**Addendum #2**

**Bid Opportunity: RFT-2025-166 - Operations Centre Garage Expansion**

ADD  
#E01

ADD  
#M01

AUG./08/2023

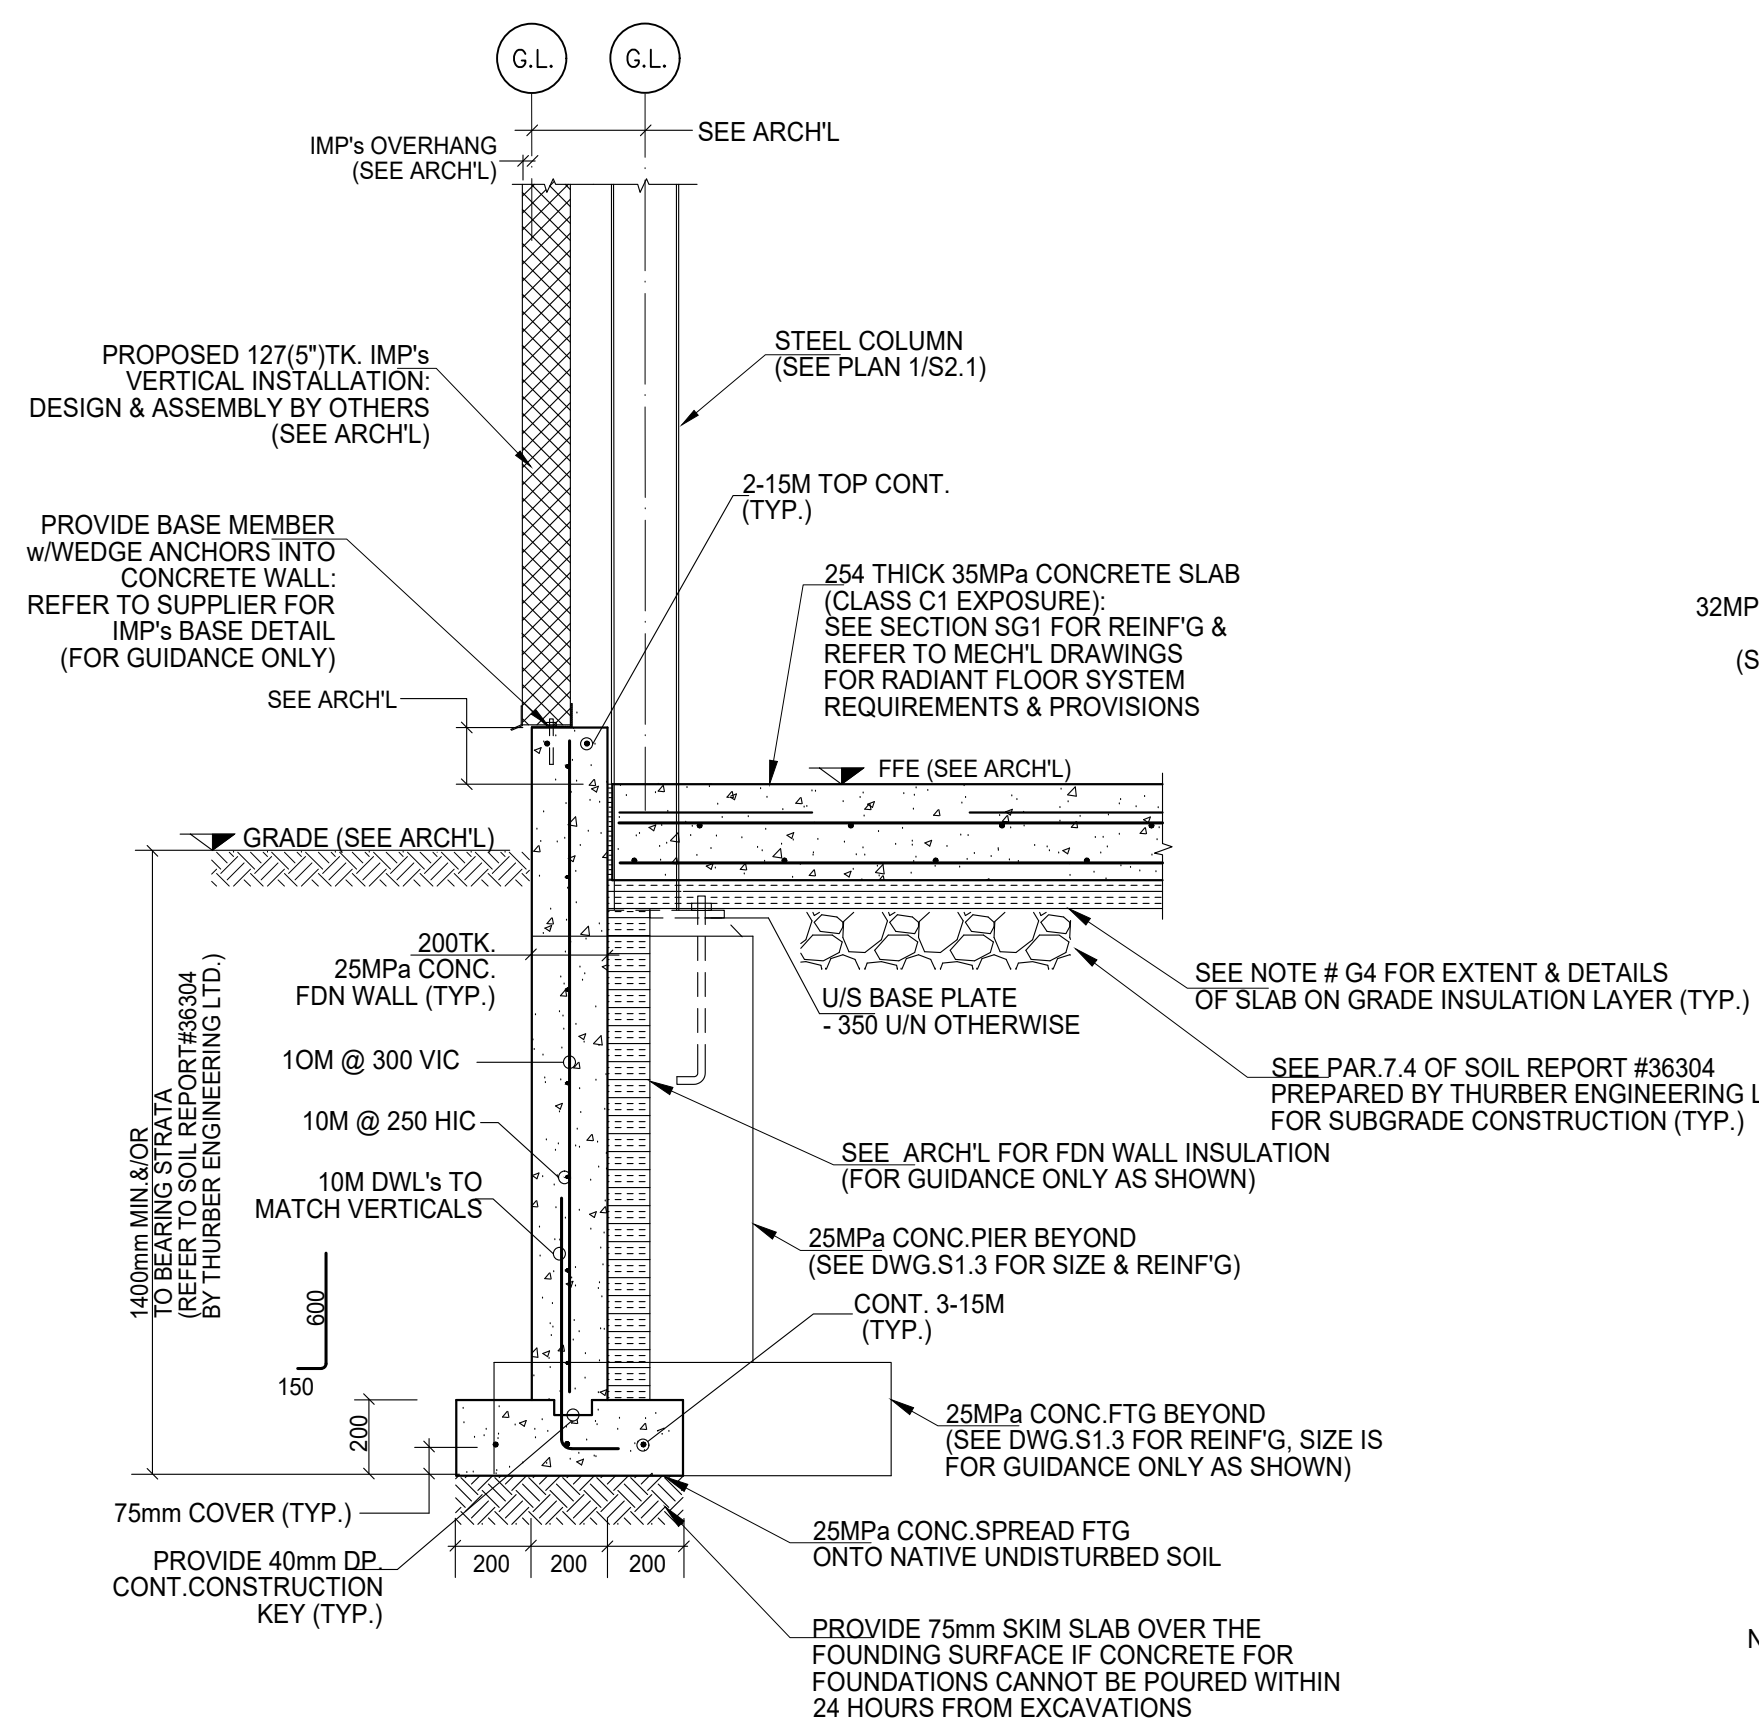
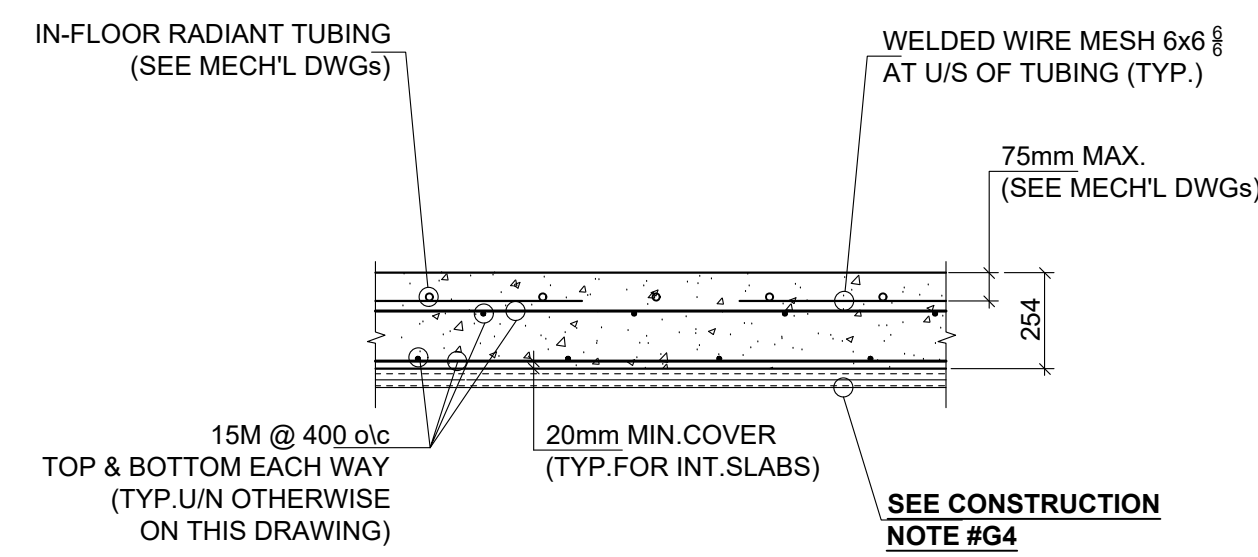
Conflicting notes between plan A-102 notes 3in. tk. insul. at perimeter and then plan S2.1 note G4 states 2in. tk?

**Answer 12:** For clarification, as per the architectural drawing A-102 the thickness of the perimeter insulation will be 3 in. See attached & updated structural drawings S2.1 & S2.2 indicating the thickness of the perimeter insulation has been revised from 2 in. to 3 in.
